ADDENDUM No. 1

Building 5170 Renovation – Camp Williams Reference:

DFCM Project No. 08032470

ADDENDUM #1 RENOVATION OF READINESS CENTER BUILDING 5170 CAMP WILLIAMS, UTAH

We trust this is the information you require.

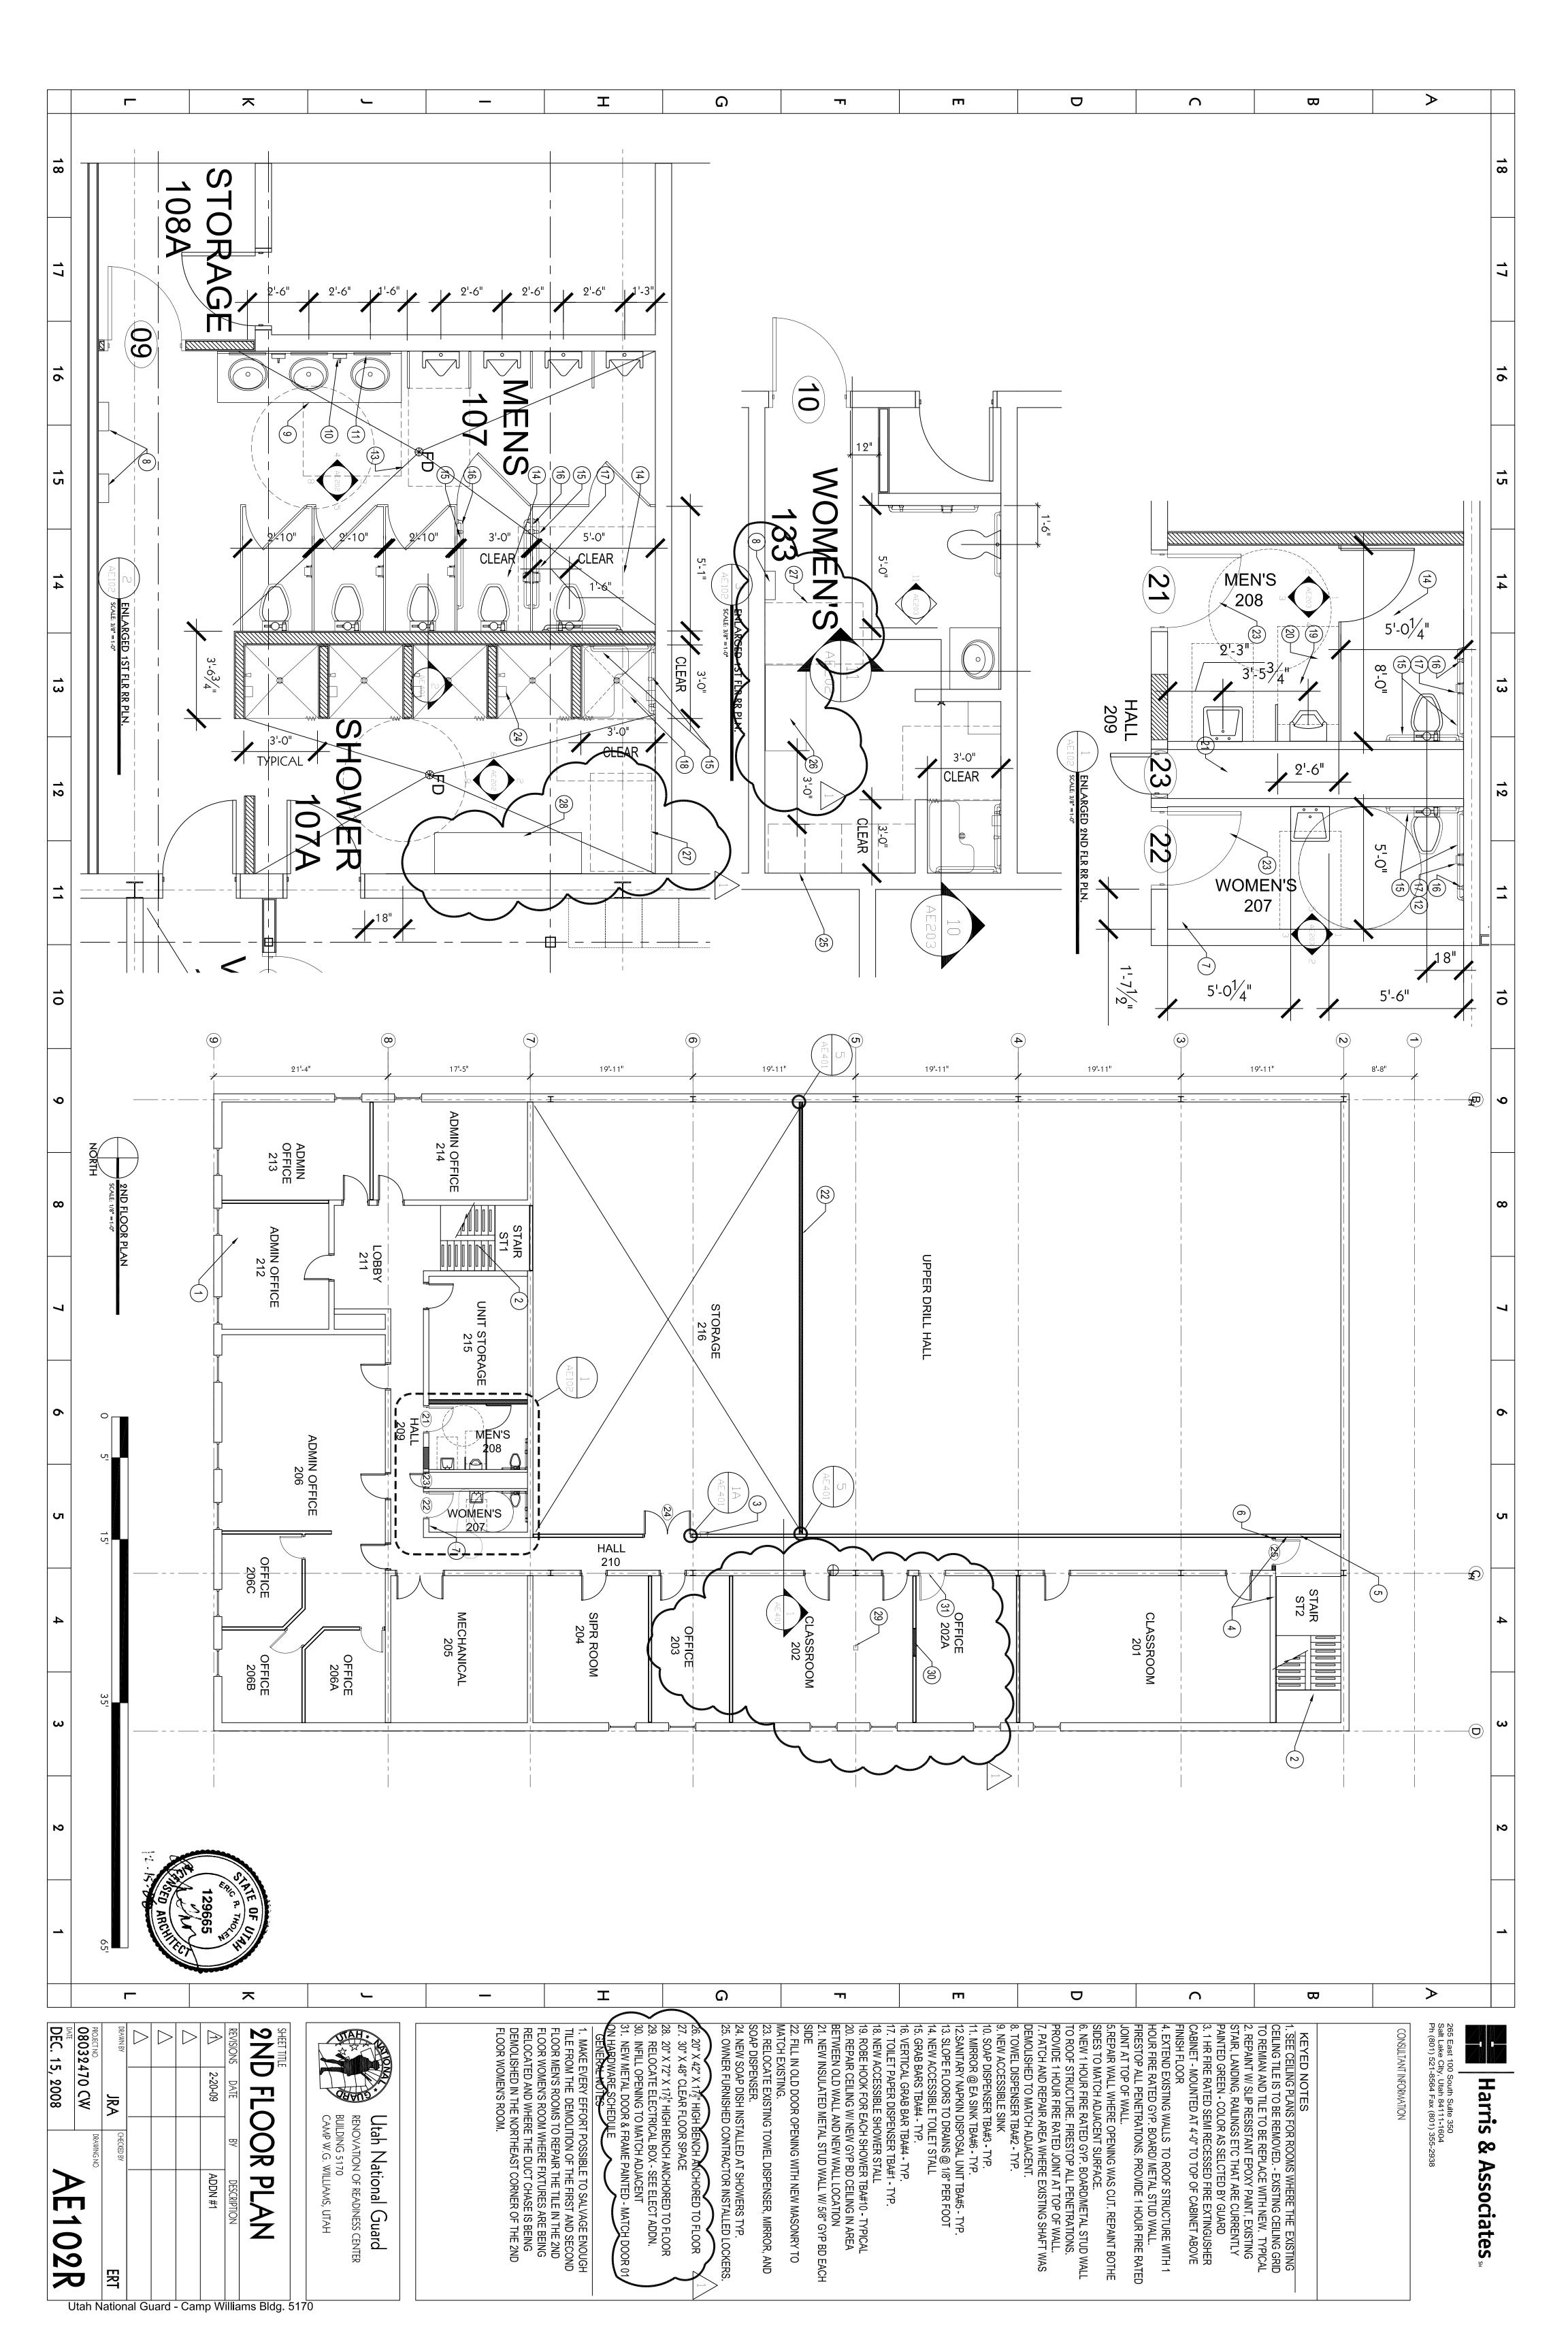
- 1. Assembly Hall 113: Provide 3-each 3-way switches just to the east of the man door at gridline B:2 and 3-each 3-way switches on the wall just east of gridline of C:5. Each set of 3-way switches will control 1 row (1 circuit) of the high bay fluorescent light fixtures.

- 2. The "Cable Tray" shown on sheets EP101 and EP102 is 12 inch wide basket tray, and is not ladder type cable tray as indicated in the specifications.

- 3. Add a 4-inch conduit stub from the primary side of the new pad mounted transformer. Extend the conduit stub, out a minimum of 5-feet beyond the concrete pad, to the east. Provide a cap and label on the spare stub out conduit for the future connection to pad-mounted switch.

- 4. HF-99 fixtures shall be from the same family and have the same performance but shall be grid mounting type or provided with flange kit for mounting in grid ceiling.

- 5. The wall between Classroom 202 and Classroom 203 has been removed and there are two power outlets stubbed above the floor. Contractor shall remove and relocate outlets to 2 separate adjacent walls in the new room. Coordinate with Utah National Guard staff for desired location of outlets.

- 6. Prior approved equals
 - a. HF-99: the equivalent fixture in Columbia Lighting is considered to be equal.
